29 Maresfield Gardens
NW3 5SD

Basement Impact Assessment
Audit

Project Number: 13398-34
Revision: F1

Last saved	28/08/2020 11:45
Path	JBemb13398-34-120820-29 Maresfield Gardens-F1.doc
Author	J Brown, BSc MSc FGS
Project Partner	E M Brown, BSc MSc CGeol FGS
Project Number	13398-34
Project Name	29 Maresfield Gardens
Planning Reference	2020/1418/P

4599 Maresfield Gardens TP records.pdf

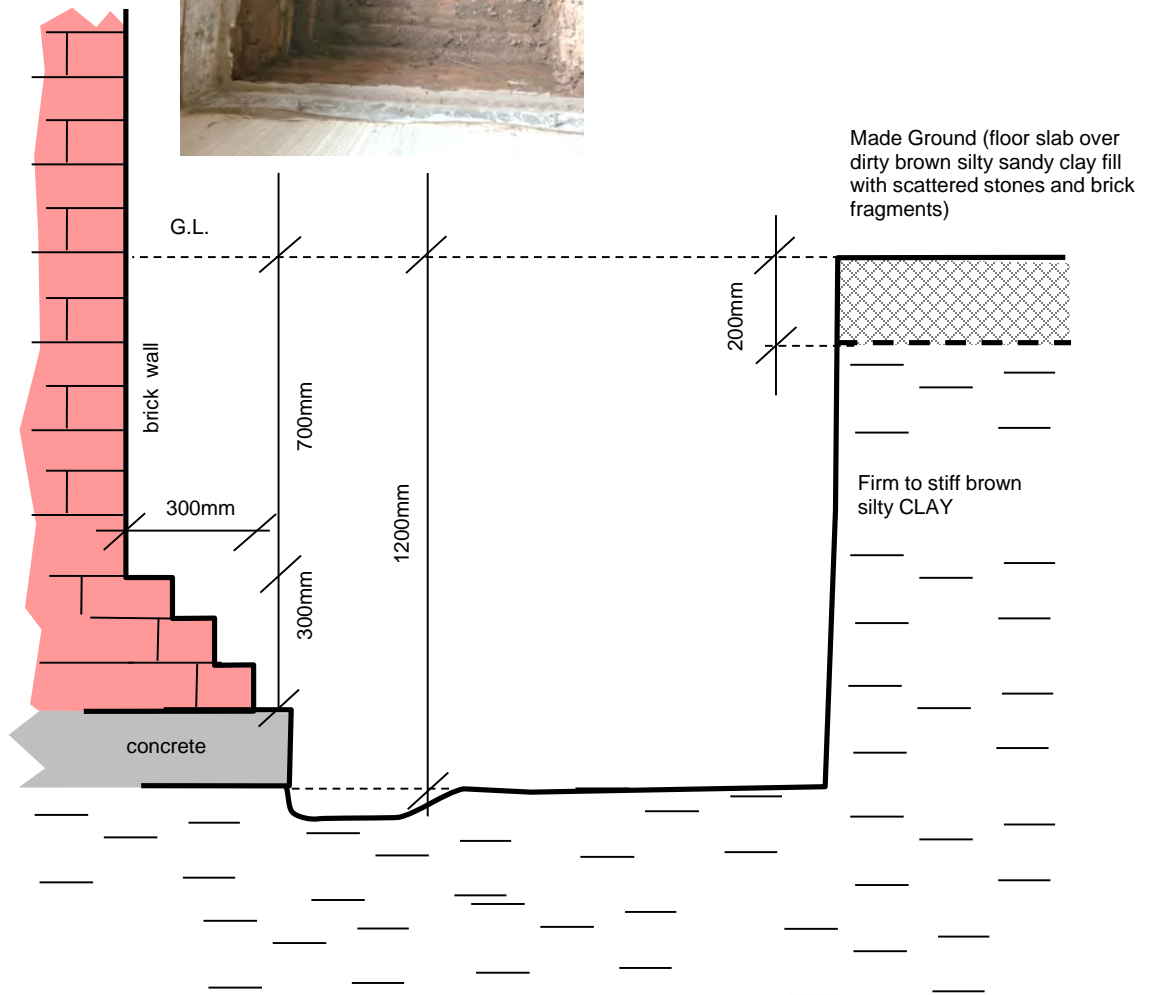
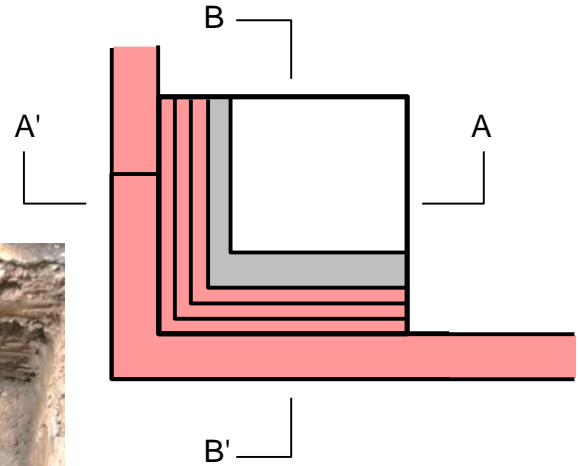
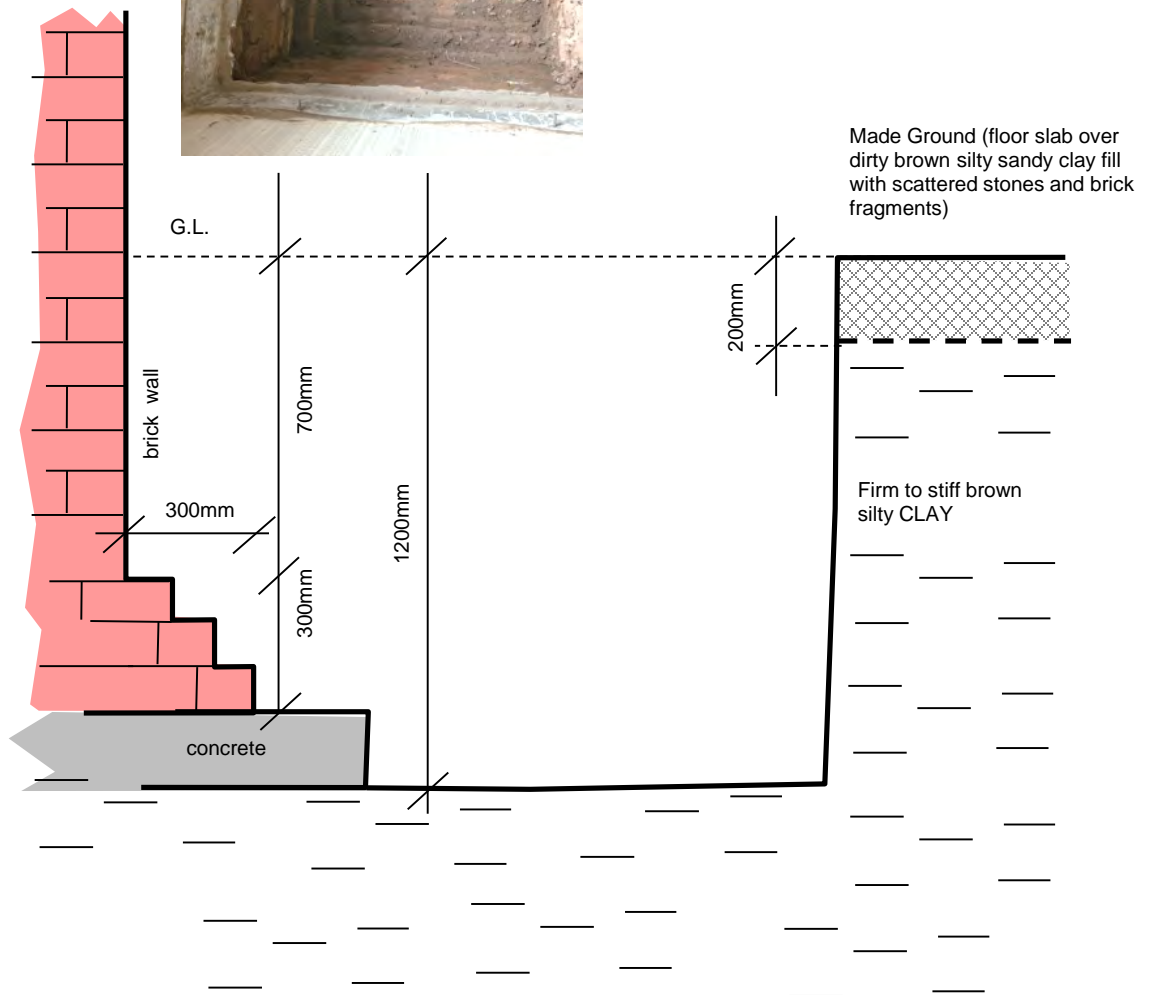
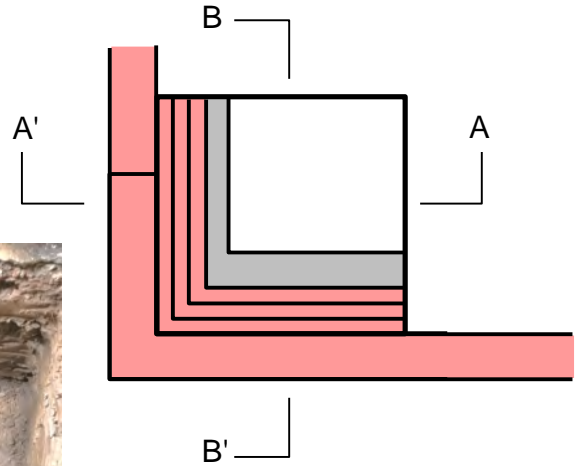
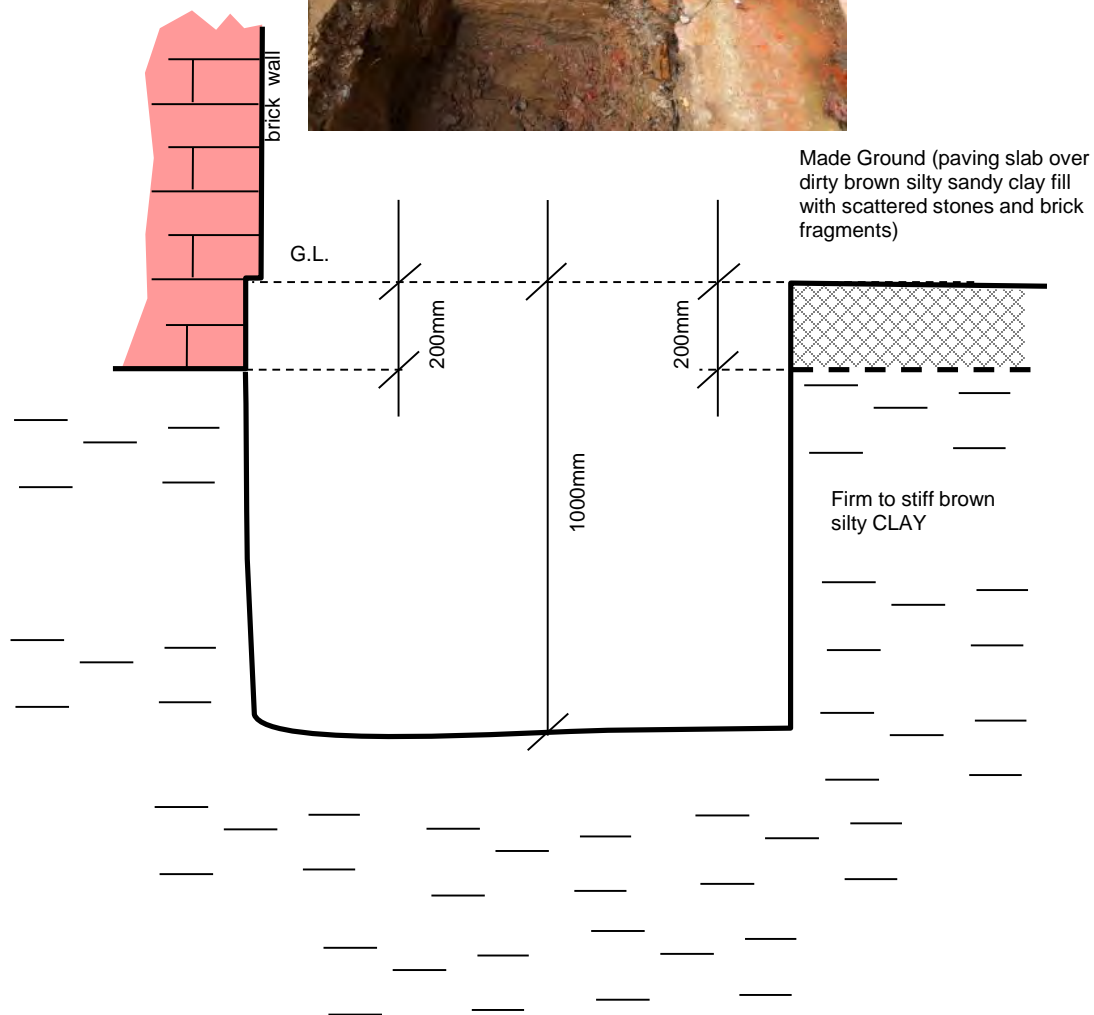
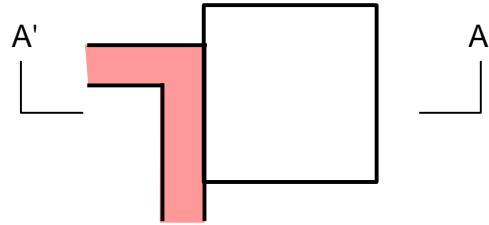
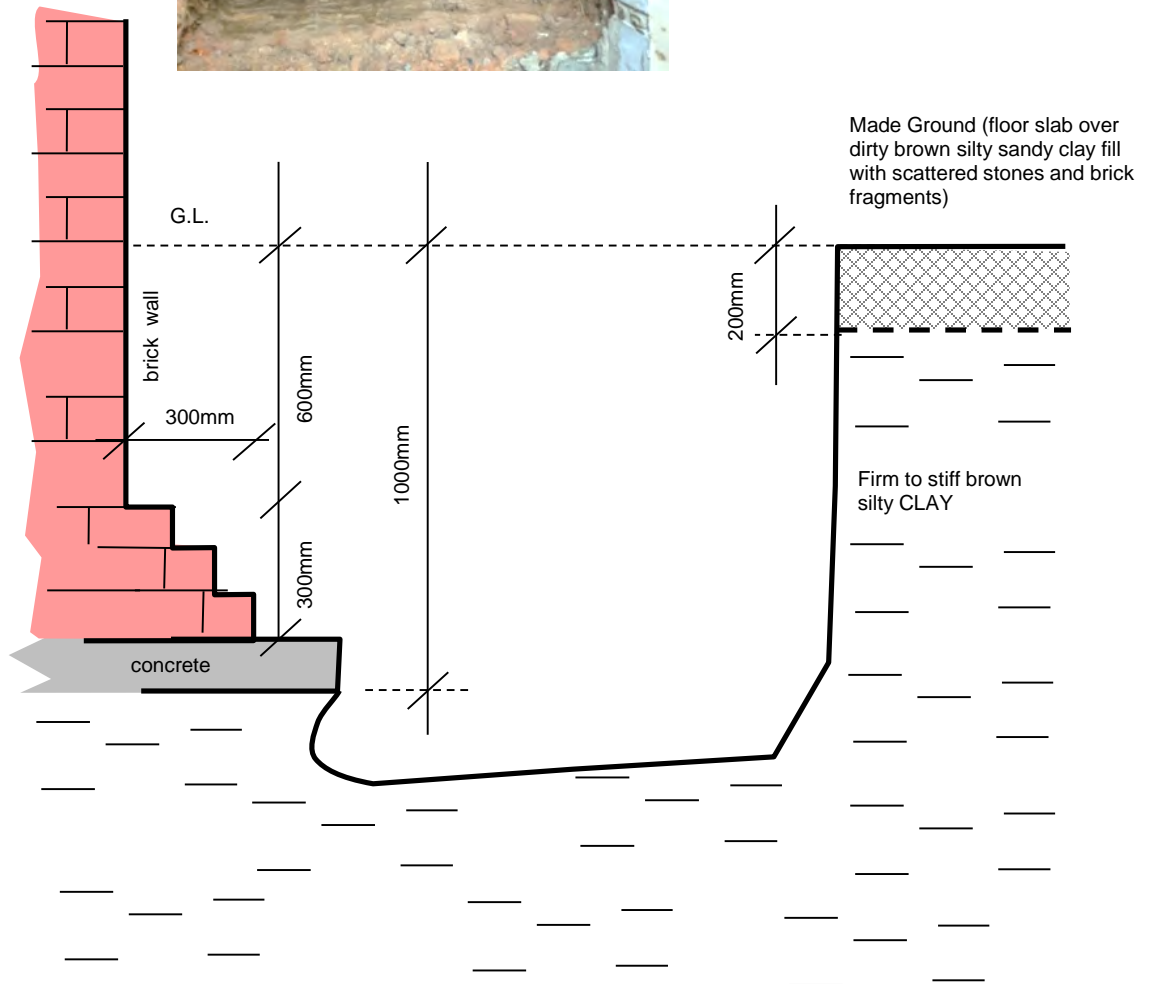
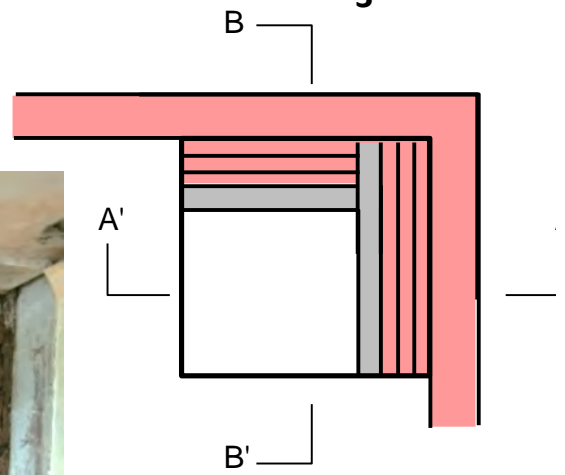
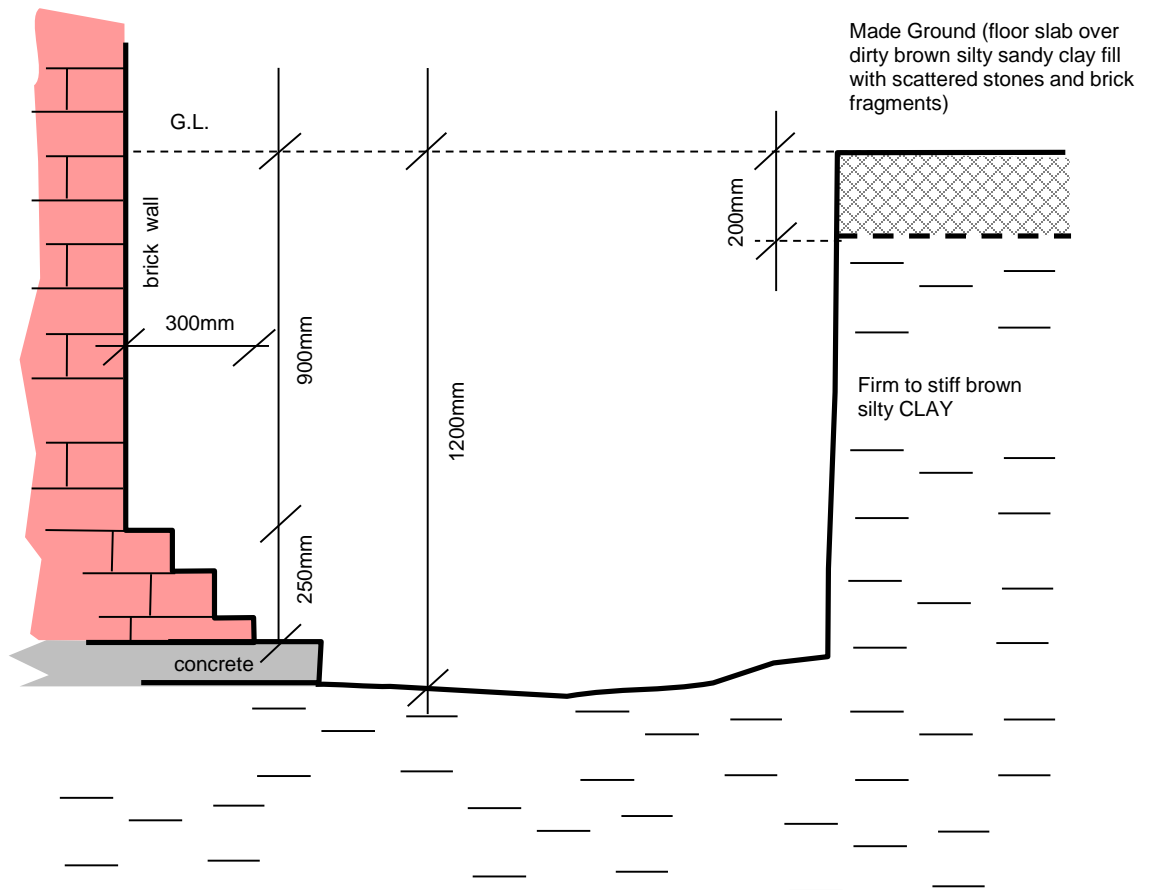
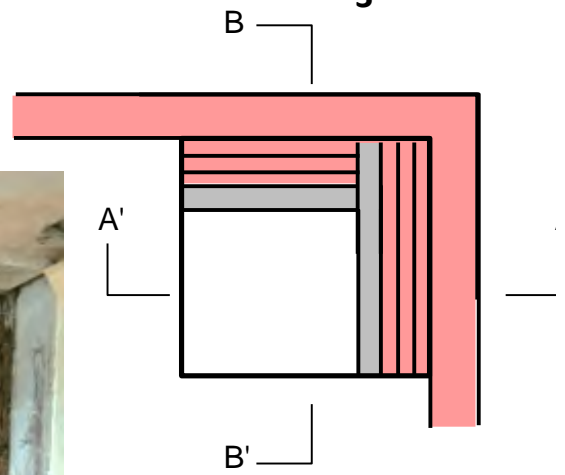
We request the Ground Investigation Report be provided to confirm the basement will be founding in competent London Clay and to confirm the undrained shear strength design value used in the BIA.

As set out in section 3 of the BIA, a series of trial pits were hand-excavated to expose the existing foundations and an inspection was undertaken by ourselves to confirm that London Clay had indeed been exposed.

Please find attached records.
